23rd November 2023 Planning Committee Addendum

Item 6.1 23/00872/FUL – Croydon Park Hotel, 7 Altyre Road, Croydon, CR9 5AA

Figure 55: proposed wind conditions in relation to nodal point 89

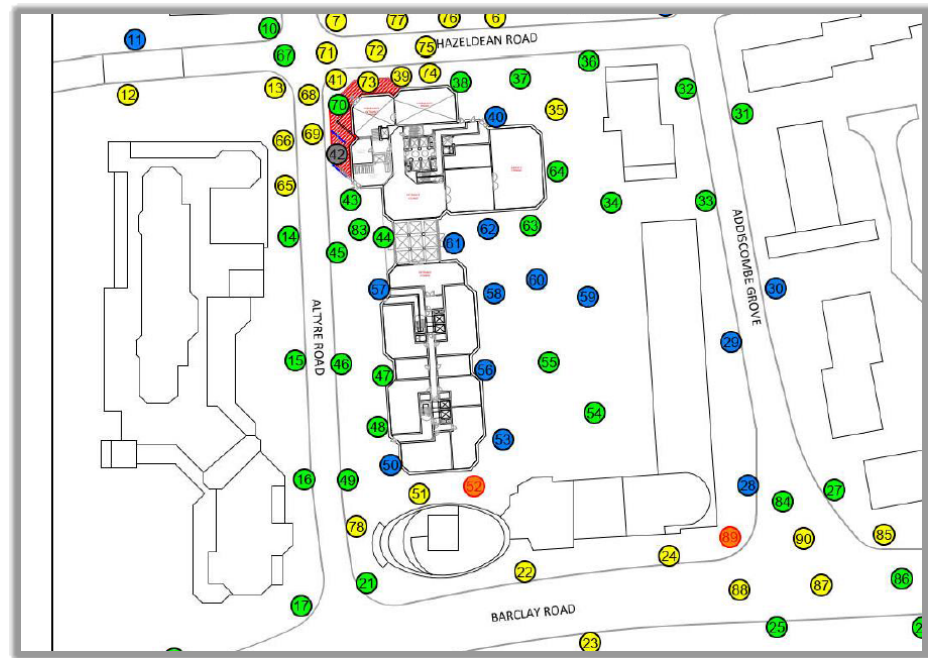
Paragraphs 8.158 to 8.163 should be deleted (they are covered in paragraphs 8.207 to 8.213)

8.162 — The applicant's Wind Assessment, the independent Review and third parties raised concerns regarding the undesirable wind condition at the corner of Barclay Road and Addiscombe Road, to the east immediately outside of Latitude Apartments (nodal point 89). Through wind tunnel modelling this corner position shows existing uncomfortable walking conditions. The application before Members does not make this position any worse and therefore there would be no greater concerns in regard to public safety; this position has been supported by the Council Consultants.
